**PLANNING DEPARTMENT ADMINISTRATIVE PUBLIC HEARING
SUMMIT COUNTY, UTAH
August 29, 2024**

Subject: 1115 Aerie Drive
Application: PL-21-05100
Author: Jacob Klopfenstein, Planner I
Date: August 29, 2024
Type of Item: Administrative Conditional Use Permit

(I) Review the Administrative Conditional Use Permit (ACUP) for a Fence and retaining walls greater than six feet in height, (II) conduct a public hearing, and (III) consider approving the ACUP based on the Findings of Fact, Conclusions of Law and Conditions of Approval outlined in the Draft Final Action Letter (Exhibit A).

Figure 4: 1115 Aerie Drive sports court and retaining walls site plan.

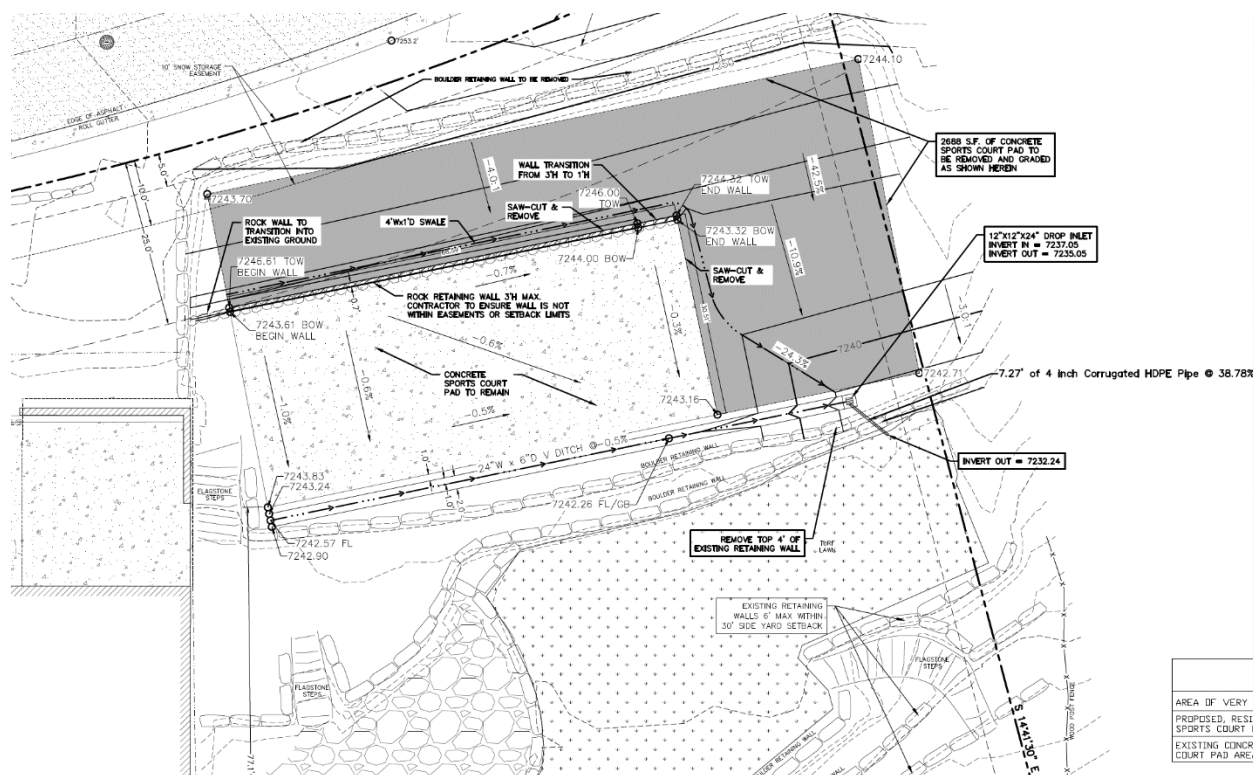
Per the Applicant, after reducing the size of the sports court, the area north and east of the sports court will be regraded (see Exhibit B, 1115 Aerie Drive Updated Grading and Drainage Plan). As part of the regrading work, the top four feet of the existing retaining wall will be removed, and the retaining walls will not exceed 6 feet.

The retaining walls are built to the south of the sports court and within the Side Setback. Per the Applicant, the retaining walls range from under four feet to eight feet in height and provide level areas for landscaping and outdoor amenities, including a playground, at the Site. The below photos show the retaining walls immediately south of the sports court and the astroturf playground area:

Condition of Approval 1 –Retaining walls within the Side Setbacks may have multiple steps, however, each exposed face shall not exceed six feet in height and the horizontal distance between the walls, front face to rear face, must be at least three feet and planted with approved vegetation.

Condition of Approval 6 – Retaining walls on the site shall not exceed 6 feet in height. The applicant shall remove excess height from retaining walls exceeding 6 feet in height.

Figure 6: Retaining wall below astroturf playground area and within the Side Setback at 1115 Aerie Drive.

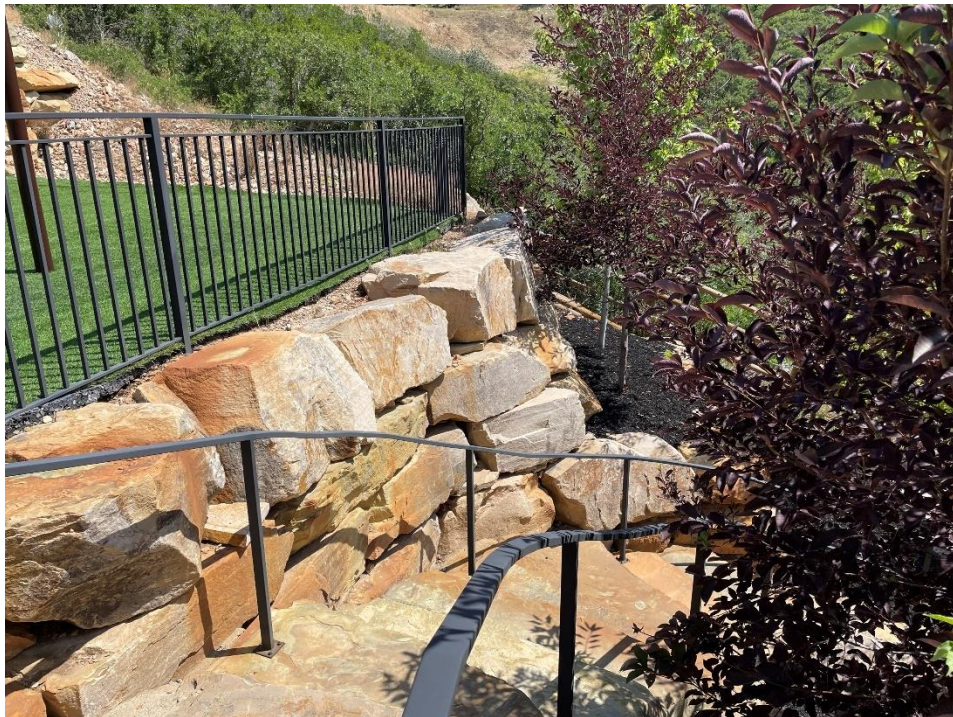
The retaining walls are not screened on the south side and are not visually separated from adjoining Uses. LMC § [15-5-5\(N\)](#) requires at least 50 percent of the Landscaped Area be Water Wise Landscaping containing approved non-invasive drought tolerant plants, and/or minimal irrigation. Staff recommends the following:

Condition of Approval 5 – The Applicant shall implement additional landscaping or vegetation that shall fully screen the retaining walls south of the sports court from adjoining Uses. At least 50 percent of the Landscaped Area shall be Water Wise Landscaping containing approved non-invasive drought tolerant plants, and/or minimal irrigation, pursuant to LMC § 15-5-5(N).

Figure 8: Landscaping plan for 1115 Aerie Drive showing trees proposed for the north and east sides of the reduced-size sports court and shrubs on the south side of the sports court.

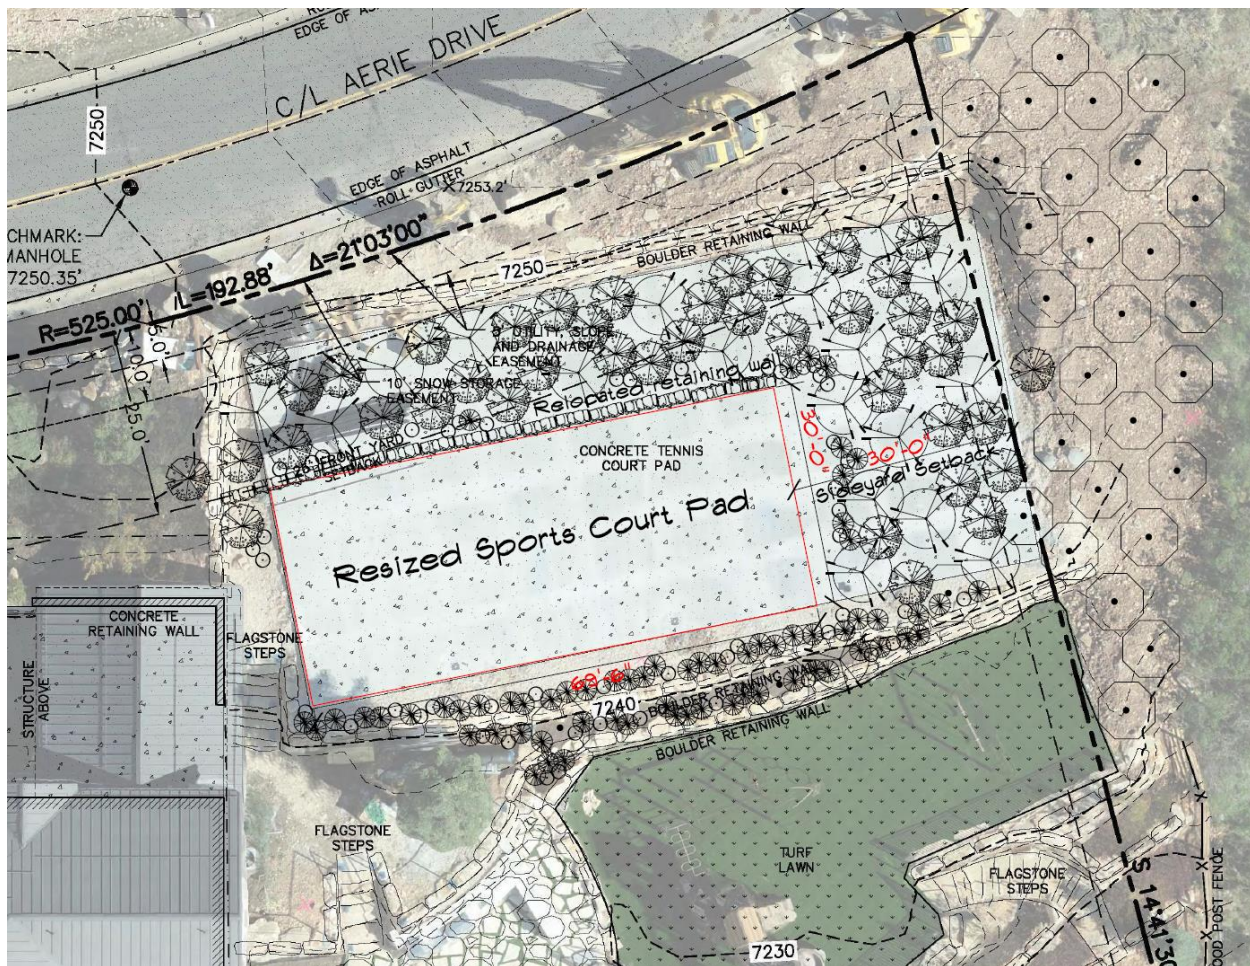
Evergreen Spruce trees typically reach 60-200 feet in height, Autumn Blaze Maple typically reach 40-60 feet in height, and Quaking Aspen typically reach 40-50 feet in height. The Karl Foerster plants typically reach heights of up to six feet and Russian sage reaches heights of up to three feet.

With the proposed shrubs, the 10-foot-tall Fence would be only partially screened on the south side from adjoining Uses. The Fence would be visible from other nearby Single-Family Dwellings to the north and south along Aerie Drive and to the east along Mellow Mountain Road, which is higher in elevation than 1115 Aerie Drive. Surrounding neighboring Single-Family Dwellings are situated above 1115 Aerie Drive, which is located on the side of a hill overlooking a small canyon. The Site is visible from other properties along Aerie Drive and Mellow Mountain Road, as well as other properties in Old Town Park City and across the canyon in the Treasure Hill area.

Condition of Approval 4 – The Applicant shall implement additional landscaping or vegetation that shall fully screen the 10-foot-tall Fence from adjoining Uses. At least 50 percent of the Landscaped Area shall be Water Wise Landscaping containing approved non-invasive drought tolerant plants, and/or minimal irrigation, pursuant to LMC § 15-5-5(N).

Figure 9: Visual assessment of 1115 Aerie Drive showing Vantage Point at Main Street and Heber Avenue.

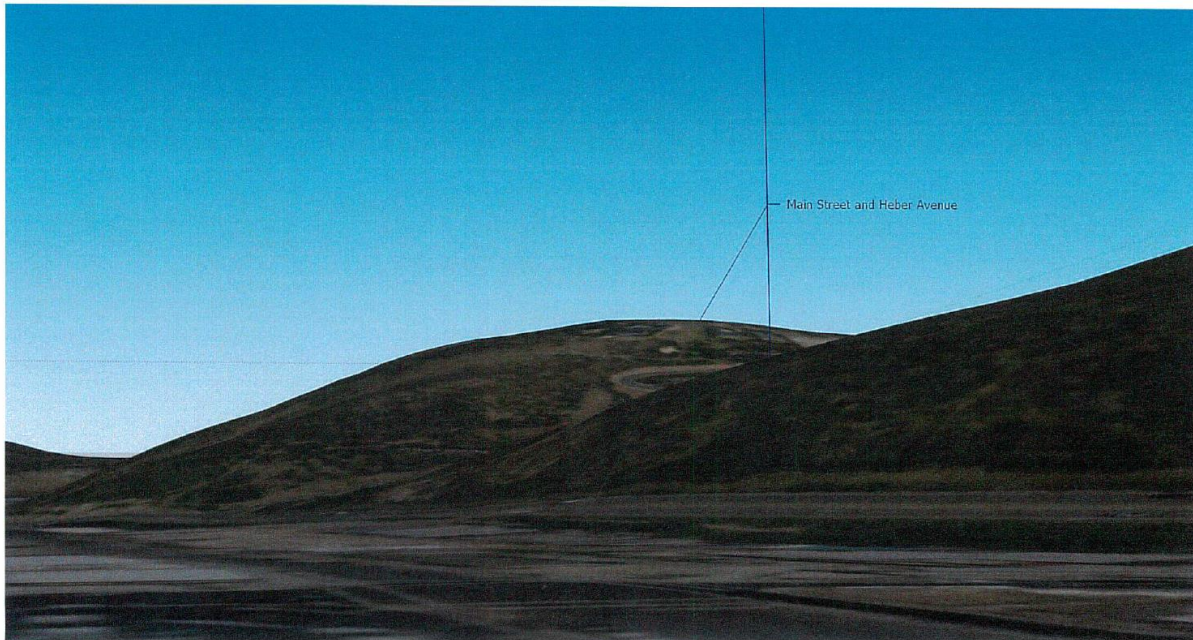
The 10-foot-tall glass Fence would extend 69 feet, 6 inches along the length of the sports court and 30 feet along the depth of the court, enclosing an area 2,085 square feet in size. The Fence, as proposed, is partially screened on the south side (see Exhibit F, Landscaping Plan for 1115 Aerie) and would be visible from neighboring Single-Family Dwellings to the north and south along Aerie Drive and to the east along Mellow Mountain Road.

The Applicant's visual assessment (Exhibit H), completed in 2021 as a part of the required sensitive lands analysis, shows that the Site is visible from Vantage Points within Old Town Park City, such as the intersection of Main Street and Heber Avenue:

Condition of Approval 11 – The Applicant must landscape and revegetate exposed Slopes. Topsoil from any disturbed portion of a Steep Slope must be preserved and utilized in re-vegetation. Fill soil must be of a quality to support plant growth.
